APPLICANT: Paul Manley **PETITION No.:** V-62

Application for Variance Cobb County

V-62
(2015)
Exhibit

V-62

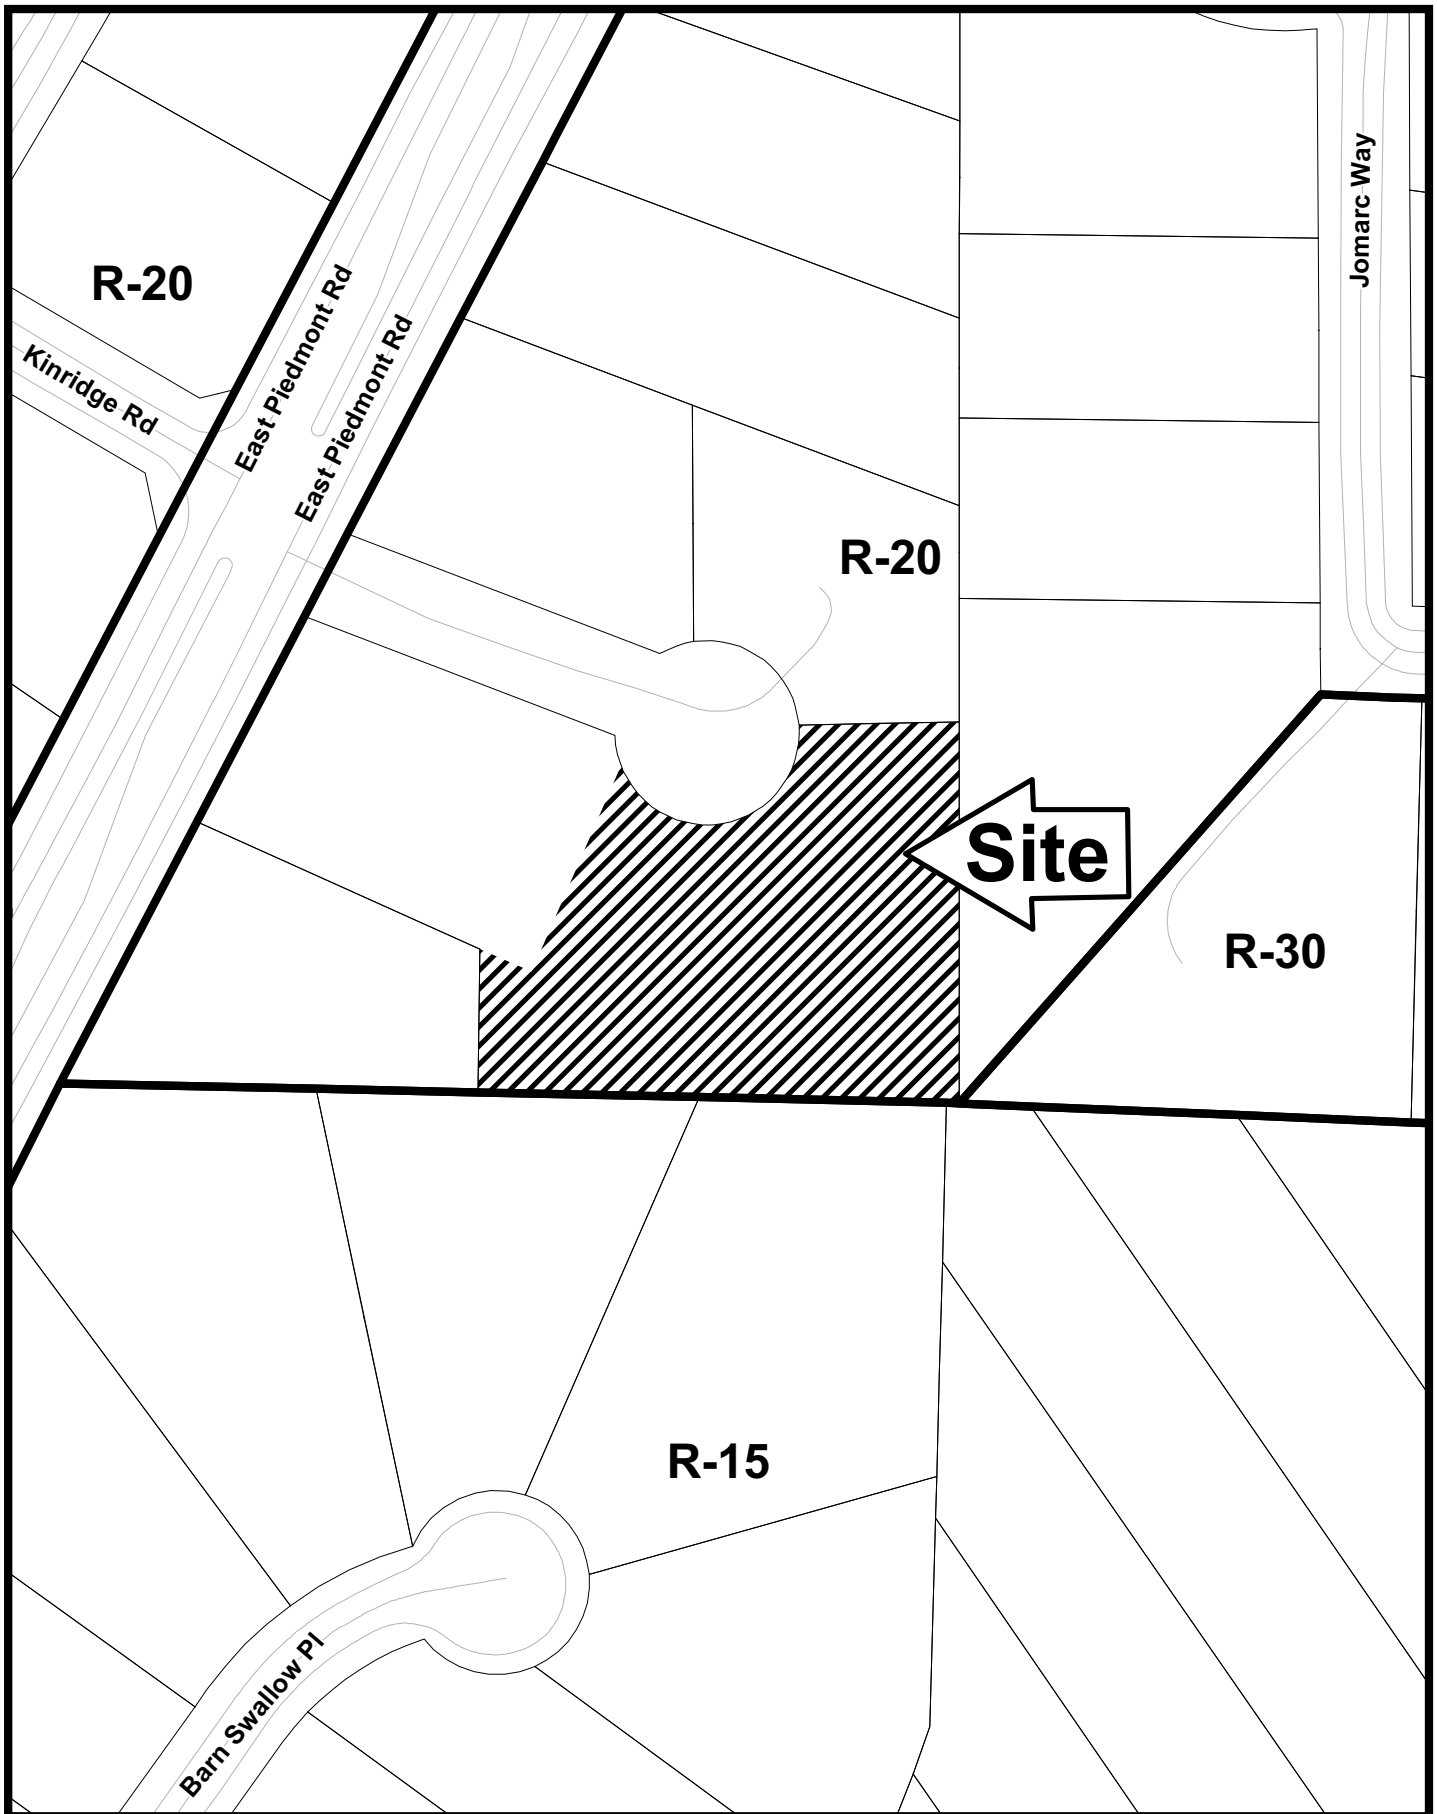
TRAFFIC: Recommend Dayron Court be paved to a width of 20' including the cul de sac with 38' radius.

SITE PLAN REVIEW: If this variance request is approved, a subdivision plat revision must be recorded prior to the issuance of the certificate of occupancy showing all improvements on the lot and referencing the variance case in the standard plat revision note. The surveyor must submit the plat to the Site Plan Review Section, Community Development Agency for review and approval prior to recording. Call 770-528-2147.

- Driveway must have a minimum 12' driving surface width with minimum 25' inside turning radius.
- Fully developed landscaping shall be at least 7'0" from center of drive (14' clear width) and 13'6" vertical clearance. (Indicate on plan minimum setbacks).
- Maximum grade shall not exceed 18%.
- Driveway must extend within 150' of the most remote portion of the structure.
- Driveway is limited to 1000' maximum from roadway unless an approved turn-around is provided. (See note below.)
- Driveway must support 25 Tons (50,000 lbs.)
- Provide emergency access to all gates securing Fire Dept. access with a minimum 12'-0" clear width
- Hydrant within 500' of remote structure, minimum 6" main*
(Required Flow: 1000 gpm @ 20 psi)
- Fire Flow Test from closest existing hydrant*
(Required Flow: 1000 gpm @ 20 psi)
